The Chimes, Uxbridge

External signage planning feedback

Feb 2025

Market Square Entrance - High level glazing

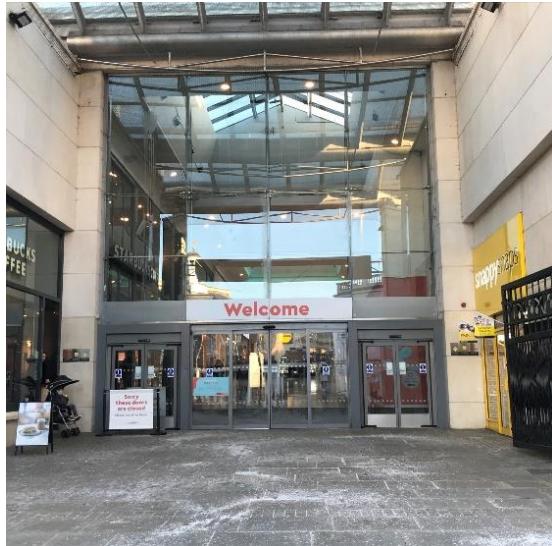
Given its central and sensitive location - being the key piazza in Uxbridge town centre and within the conservation area - we strongly object to the proposed signage in this location. The excessive coverage obstructs important visual links between the outdoor public realm, the High Street, and the internal public realm within The Chimes. It also significantly reduces natural daylight entering the main entrance hall, which in turn diminishes the quality of the public realm both inside and out. In this location, we may be open to a more restrained signage approach that respects the visual permeability and daylight qualities of the entrance. Any signage should:

- *Be minimally intrusive, ensuring clear views in and out.*
- *Maintain a sense of openness, reinforcing the connection between the street and the interior.*
- *Avoid blocking upper-level glazing, preserving daylight penetration.*
- *Be well-integrated within the architectural composition rather than appearing as an afterthought.*
- *Align with the rationalisation principles applied to other entrances, ensuring consistency.*

A more subtle, carefully designed solution - such as signage positioned within existing framework elements or restrained use of transparent/semi-transparent materials - could be explored to maintain the integrity of this key entrance while accommodating branding needs. Details/samples of materials would be beneficial.

- The base section (Come on in) covers the internal floorplate so is not obstructing visual links or daylight but is hiding the unsightly floor joists. This area already has graphic content in place.
- The use of semi - transparent materials (contravision) was discounted as this would look unsightly from the inside (It cannot be printed double sided).
- The current location was designed to only cover the lower central section of the frontage, allowing light in at both the sides and the top.
- It is noted that the current external The Chimes illuminated sign which is situated on the outer pillars obscures part of the sightline out the centre from the inside.

- Adjust the design to reduce the coverage, size and height of the current retailer logos and move these up to create a pillarbox window, retaining clear glazing above and below for visual links between the internal and outdoor public realm. When viewed internally, the logo signs will sit in line with the existing external 'The Chimes' illuminated sign so would not have significant impact on light or visibility.
- The top of the logo signs will be aligned with the framing of the glazing to integrate with the building architecture.
